ITEM NO: 8

Application No.
18/00566/FUL
Site Address:

**Manor Farm House Binfield Road Binfield Bracknell
Berkshire RG42 4LX**

Proposal: **Erection of 1.8m high timber weave panel boundary fence.**

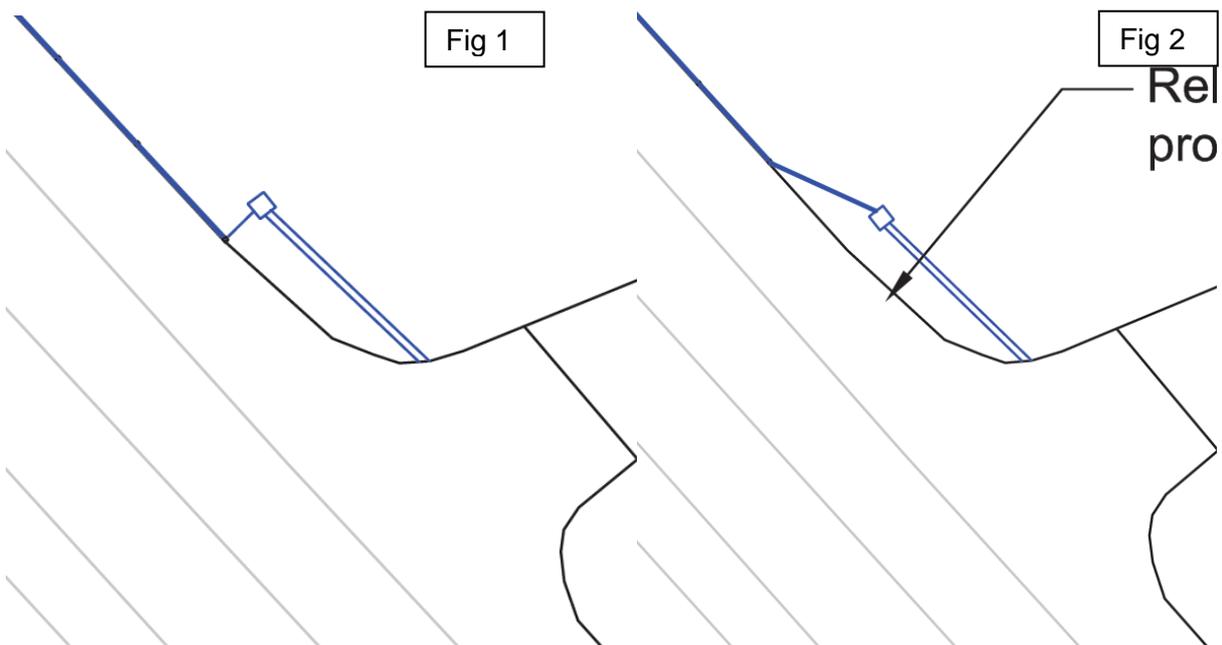
9.24 The proposed fence would have a section (3 metres in length) set at an angle between the existing set back (by 1.2 metres) section of fence immediately to the north-west of the vehicular entrance and the fence directly adjacent to the highway. The Highway Officer has been consulted on the proposed works and advises that the resulting fence line would still restrict visibility to the north for vehicles egressing the property, particularly in respect of cyclists using the shared footway and cycle path. As a consequence, the fence line would need to be splayed over a longer distance to achieve acceptable visibility.

9.25 Fig 1 demonstrates the existing position of the fence, fig 2 demonstrates the extended set-back position of the proposed fence. It is considered that the limited set-back proposed does not address the previous concerns that have been raised, both by the Local Planning Authority and the Inspector for appeal APP/R035/C/17/3176803.
